- 7. Spruce Woods Lot 1 Replat; KPB File 2022-132
Ability Surveys / Ivanov
Location: Woody Circle & East End Road
Fritz Creek Area / Kachemak Bay APC**

KPB File No.	2022-134
Plat Committee Meeting:	September 26, 2022
Applicant / Owner:	Anatoly Ivanov of Homer, AK
Surveyor:	Gary Nelson / Ability Surveys
General Location:	Woody Circle, Fritz Creek Area, Kachemak Bay APC

STAFF REPORT

SPRUCE WOODS LOT 1 REPLAT

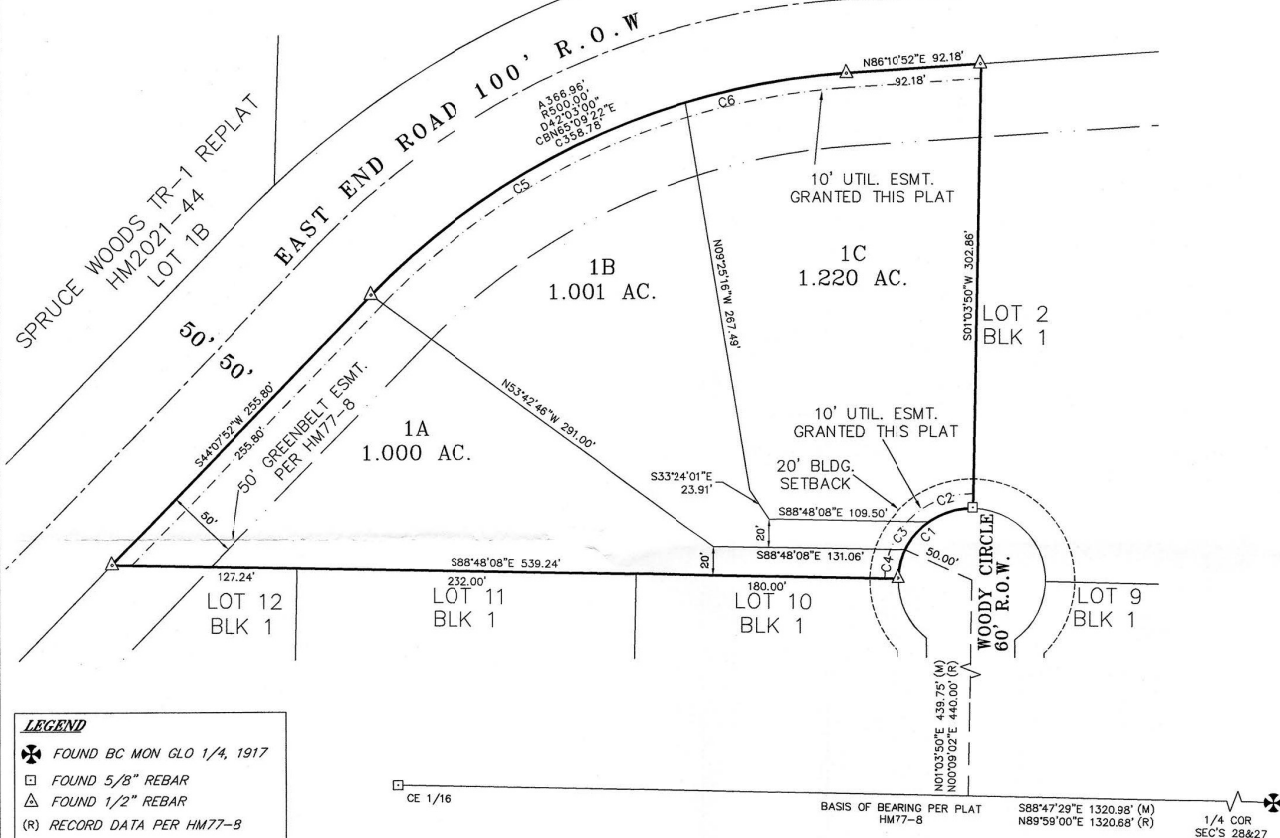
- Check the monuments found for verification of them.
- Check data totals, individual curve data is not adding up to total curve data

Staff recommendation: In the legal description add 1976 Addition to the parent plat name.

Staff recommendation: Extend Woody Cir south a little and move the name and 60' R.O.W. south also.

- D. A vicinity map, drawn to scale showing location of proposed subdivision, north arrow if different from plat orientation, township and range, section lines, roads, political boundaries, and prominent natural and manmade features, such as shorelines or streams;
Staff recommendation: *Adjust the plat depiction as currently it appears the subdivision is abutting Bonnie Avenue.*

- G. The status of adjacent lands within 100 feet of the proposed subdivision boundary or the land status across from any dedicated rights-of-way that adjoin the proposed subdivision boundary, including names of subdivisions, lot lines, block numbers, lot numbers, rights-of-way; or an indication that the adjacent land is not subdivided;
Staff recommendation: *Add the plat name and filing on the lots to the south and east.*

- J. Block and lot numbering per KPB 20.60.140, approximate dimensions and total numbers of proposed lots;
Staff recommendation: *Add Block 1 label to the lots.*

Staff recommendation: *comply with 20.60.110. Give measured and recorded distances and bearings. If recorded data is being used, check for accuracy.*

- Parent plat contained a plat note that should be carried over but reworded and may be part of note 5. "Per HM 77-8, no lot in this subdivision shall front on East End Road."

- If the plat committee concurs with the removal of the utility easement along East End Road, add "Due to the 50 foot greenbelt easement, the 10 foot utility easement per KPB 20.30.060(D) along East End Road was determined by the Plat Committee at the September 26, 2022 meeting to not be required."

- Reword plat note 2, "The front 10 feet adjacent to Woody Circle (or to "rights-of-way" if the plat committee does not concur) is hereby granted as a utility easement."

- Plat note 7 may be removed as the certificate to plat did not indicate any covenants or record.
- As there is no steep terrain, plat note 8 may be removed or updated to state none are present.

- Add a plat note with the East End Road highway map information unless provided in a label in the highway depiction.
- Add a reference to a code to plat note 6. "...lot(s), per KPB 20.30.190(B)."
